## PLANNING COMMITTEE MEETING – 10<sup>th</sup> January 2018

### Amendment/De-brief Sheet

Location: 3 Fendon Close

## FIGURE 1: View from rear side window (B)

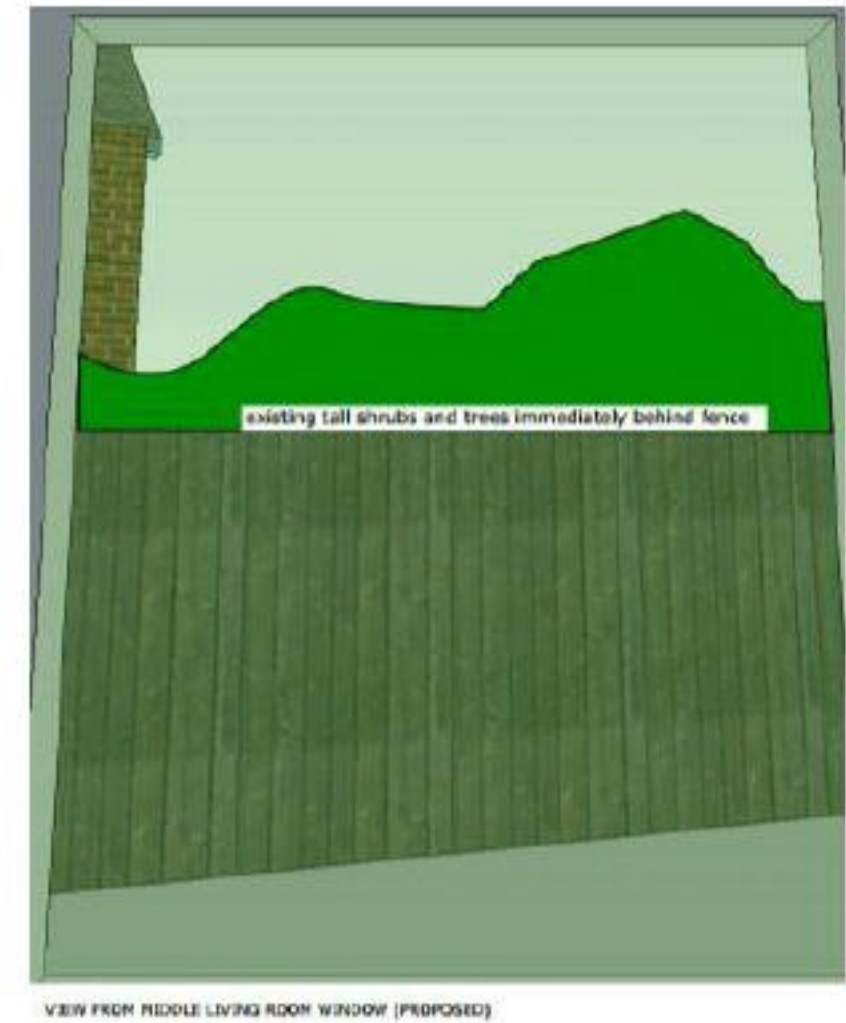
I have also attached a view of the "**claimed**" versus "**reality**" (Figure 1). There are two side facing windows to our living room (window 'A' to the front of the fireplace, window 'B' to the rear). The house was built with the living room orientated to the side, not to the rear. This unauthorized "extension" against claimed impact has resulted in further increased overshadowing. Whilst I realise that it is not in the council's interests to require the developer to demolish and for the building to match "claimed" plans with respect to the three-storey element along the boundary with no. 2, the non-structural brick wall should be rebuilt to match views claimed, **and reduced in height to match assurances made to us by the council.**

Our main living room windows are now enclosed (one fully (A), the second almost half (B)) by the development, contradicting images (claimed views) submitted by the agent when demonstrating the impact on our home; images promoted and validated by the council's planning office, contradicting statements made and assurances given to us by the council's chief executive Antoinette Jackson (*Figure 1*).

The view from our window (B) (lower photo) should match the claims made by the [REDACTED] promoted and validated to the planning committee by the planning officer [REDACTED] and assurances made to us by the council's chief executive (upper image)

**CLAIMED:**  
Applicant appears to intentionally “double” size of no. 4.

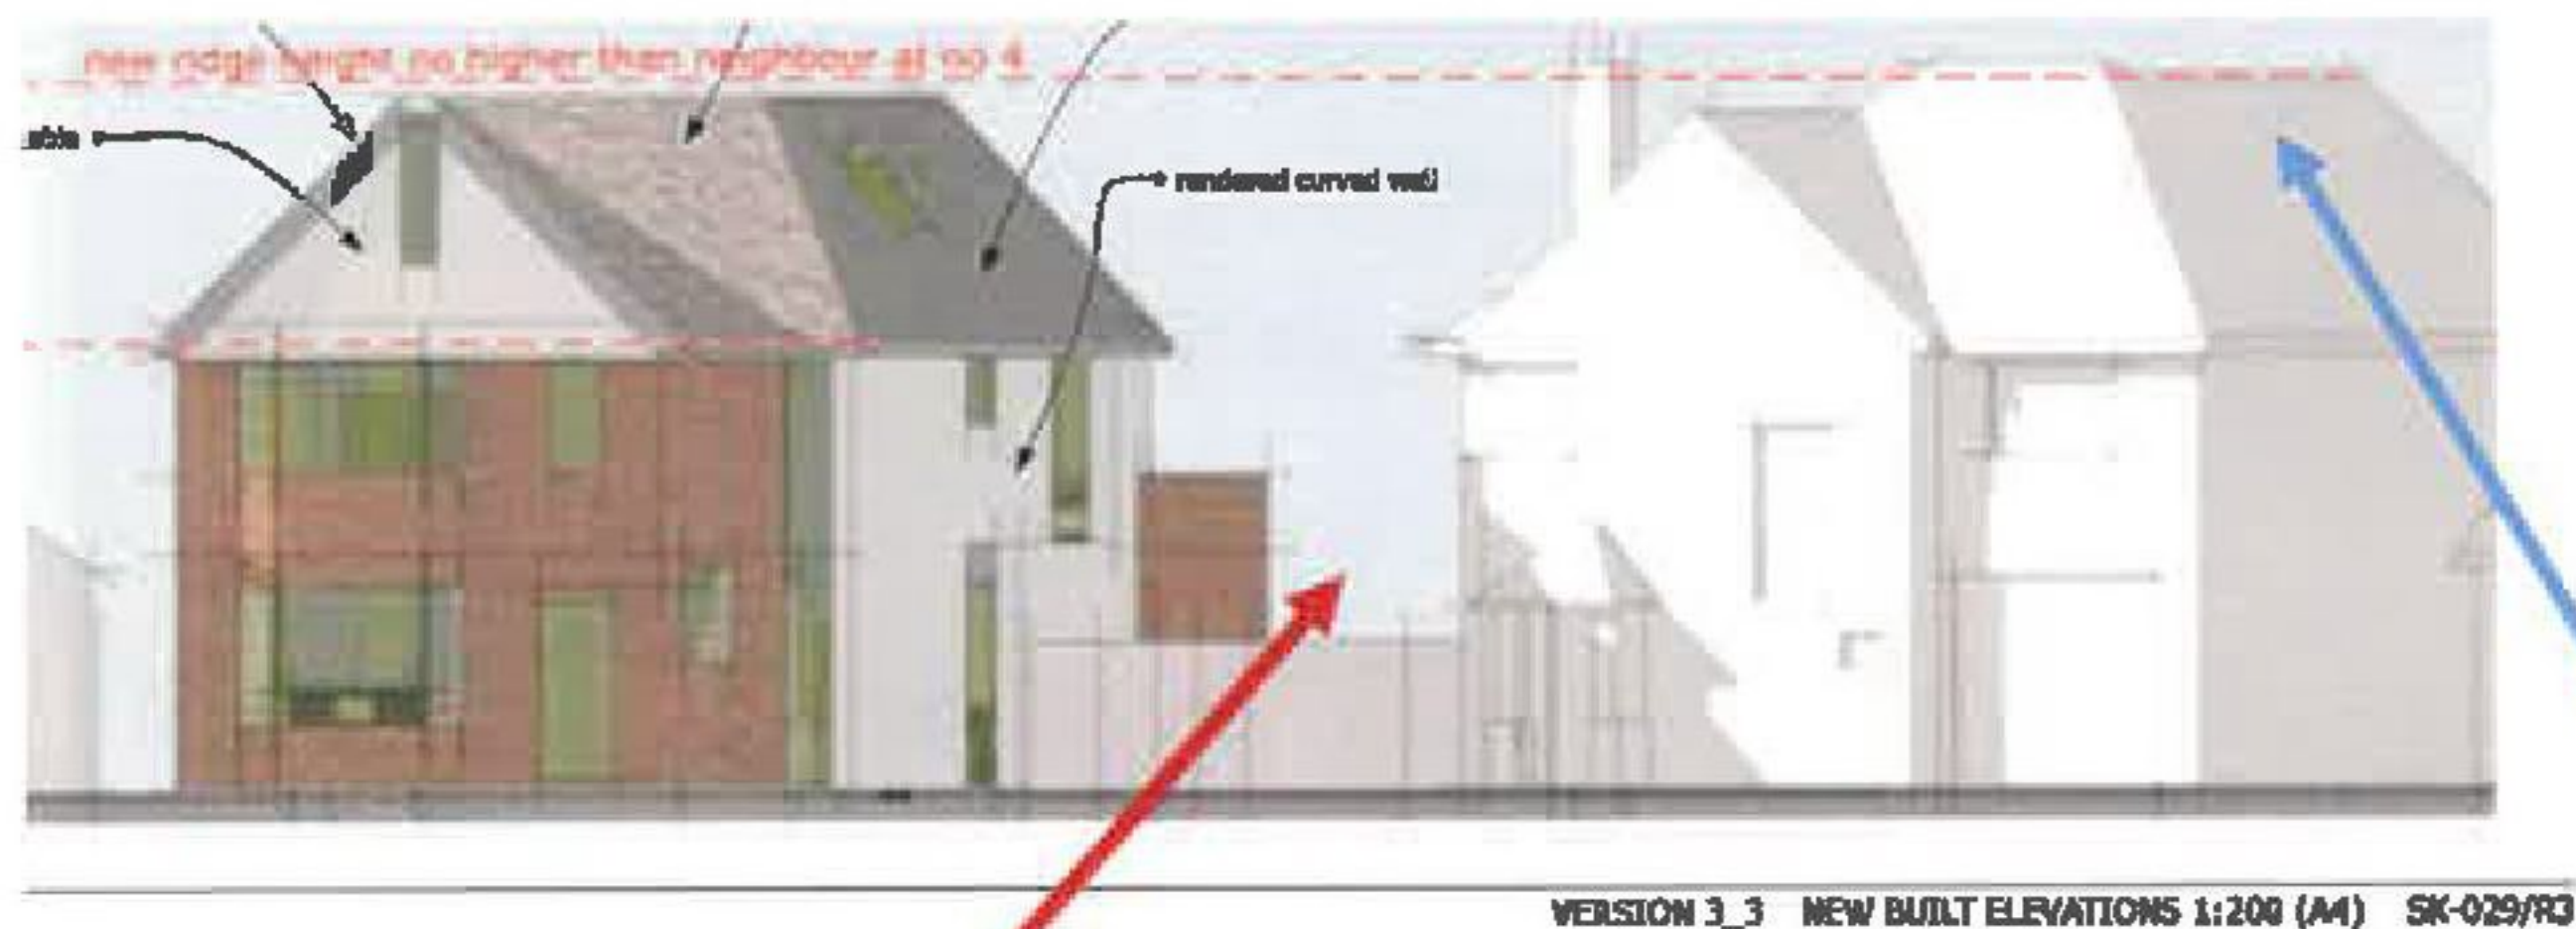
To do so, he appears to have included both the front and side elevations to artificially inflate.

**Why??**

Approved Aug-15 coloured picture: no overhang (SK-02-r3) and below (SK-035/r2)

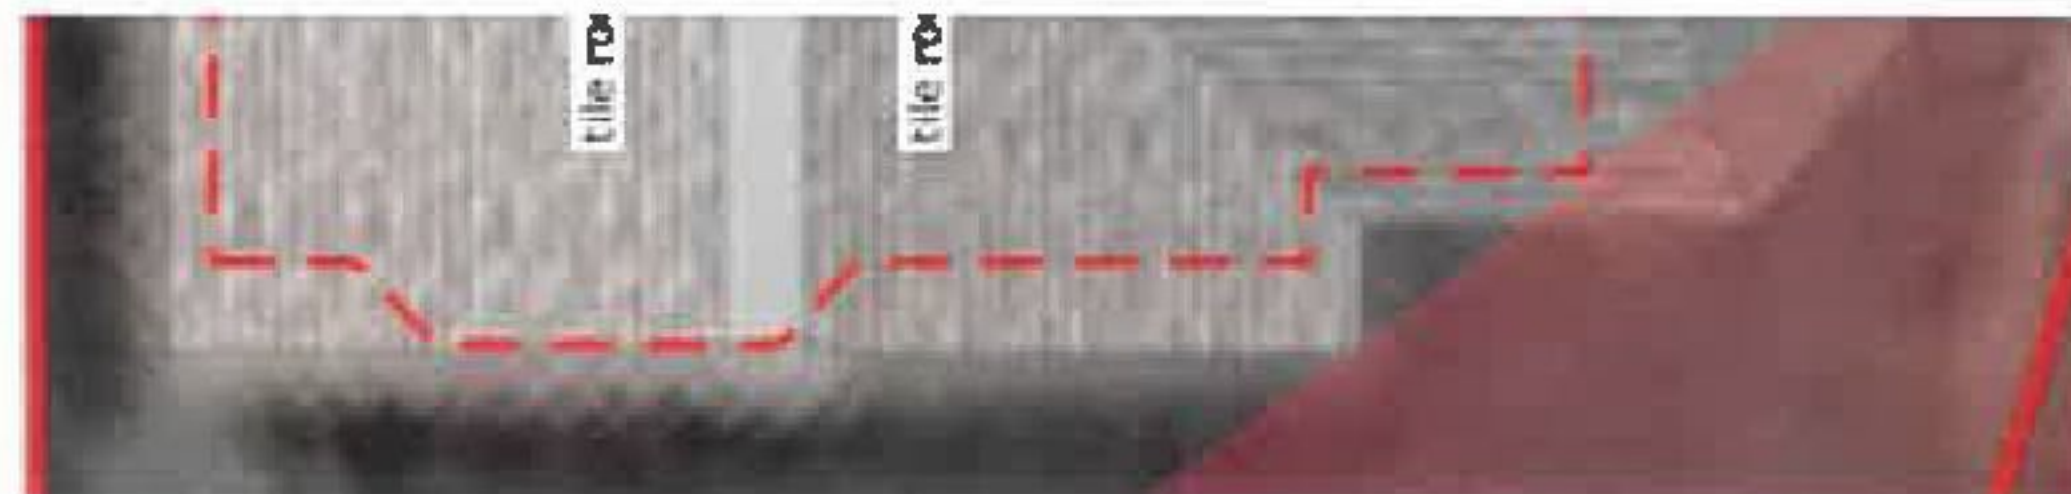
B. Image from agent's website Sep-15: substantial overhang in front of building line. As this image seems to have been published within a couple of weeks of gaining approval with images in A., why is the substantial overhang not in the (approved) images A.?

C. S73 application: Substantial overhang (SK-250/r0) but according to S73 report by the enforcement officer, roof C. is as per image A.

The approved images are blurred but clearly show no overhang.

2. Enforcement officer, written report published 2 January 2018:

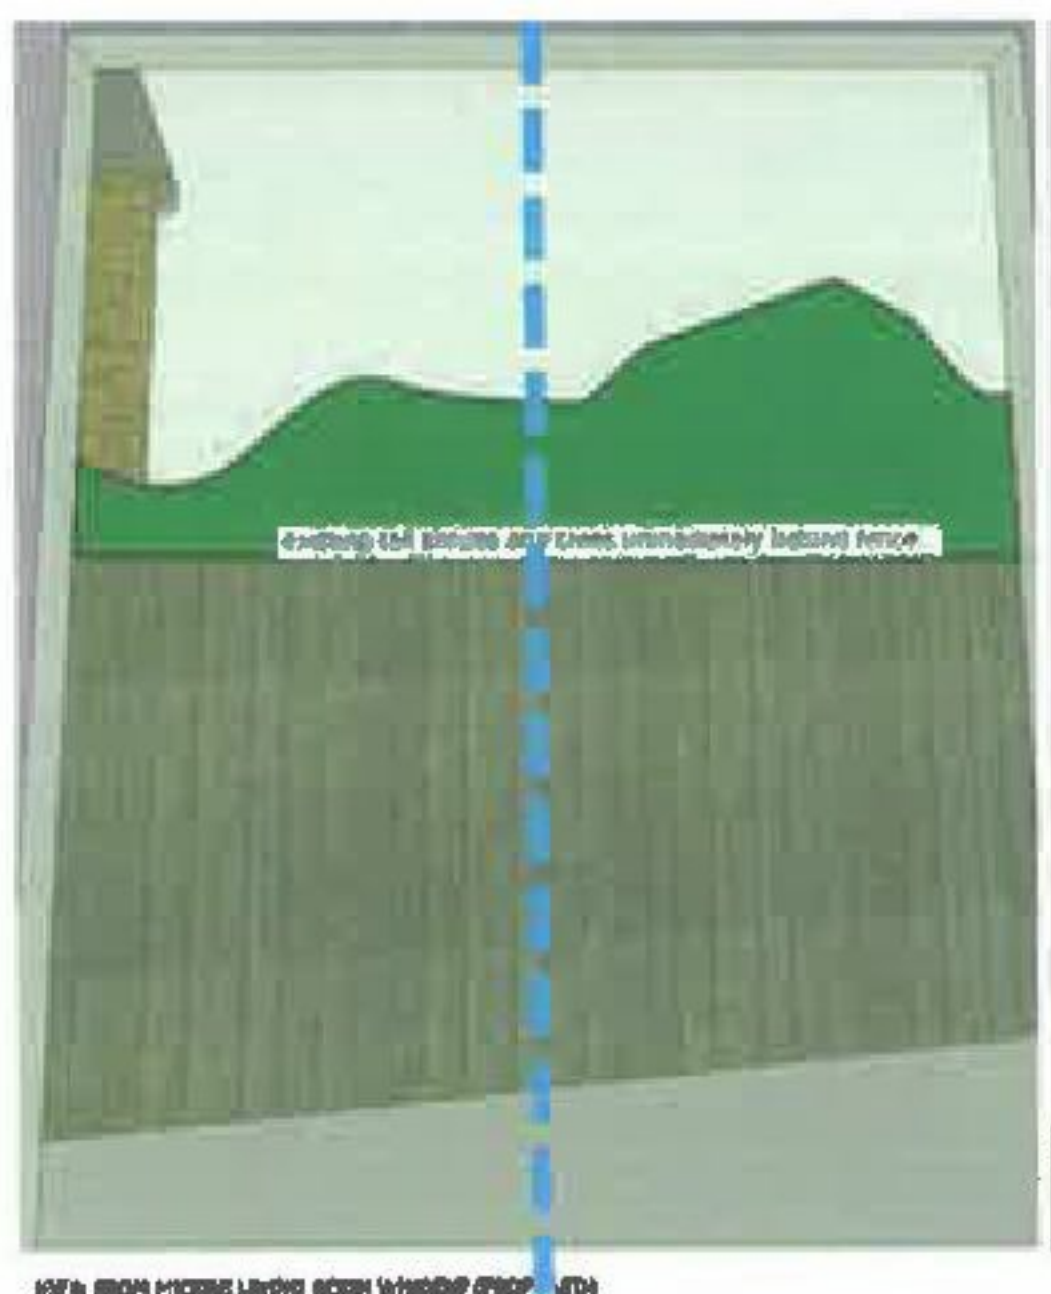
*"The height at the time of measurement was around the mark of 3.8m, depending on where one bases the true ground level. However, I can confirm that this height is exceeded at the rear flank where an additional course of bricks have been added to form a parapet wall, and coping materials were still likely to be added at the time of measurement."*

[with respect to the height of the UNFINISHED non-structural wall at the beginning of August 2017. I believe at least two further courses of bricks plus coping stone were subsequently added to the rear, with additional finishing works further increasing the height of the side wall.]

*"Measurements have been taken on site of the built structure and confirmed that the height is no higher than 3.8m."*

[with respect to the height of the FINISHED wall.]

APPROVED IMAGES SK-022/r3, SK-035/r3 AND sk-029/r3

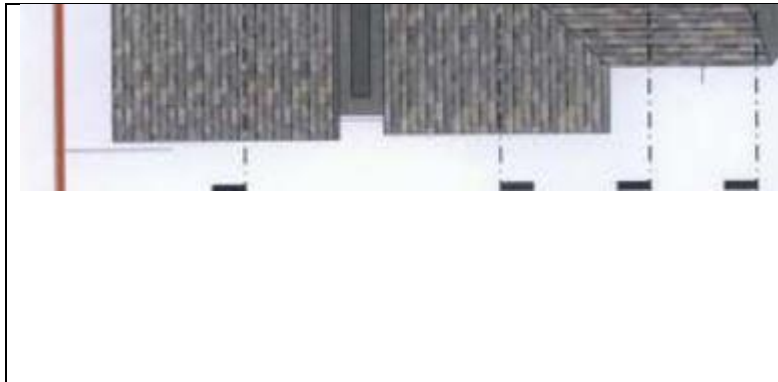
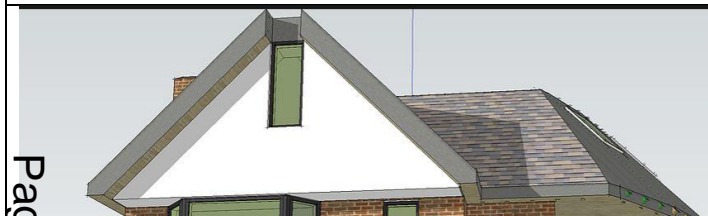
NO OVERHANG OF FRONT ELEVATION on submitted and approved plans.

S73 application include overhang but “gloss over” addition by failing to indicate change / length / wrap around of mock industrial roofing to side elevation.

Sk-250/r0	SK-251/r0	SK-251/r0
PLANNED DECISION TO BREACH PLANNING:		
	IMAGE FROM AGENTS' WEB SITE NEWS - SEP-15 (WITHIN A COUPLE OF WEEKS OF GAINING APPROVAL )	
BRICK NON-STRUCTURAL BRICK WALL ALONG BOUNDARY BETWEEN NO. 3 AND NO. 4
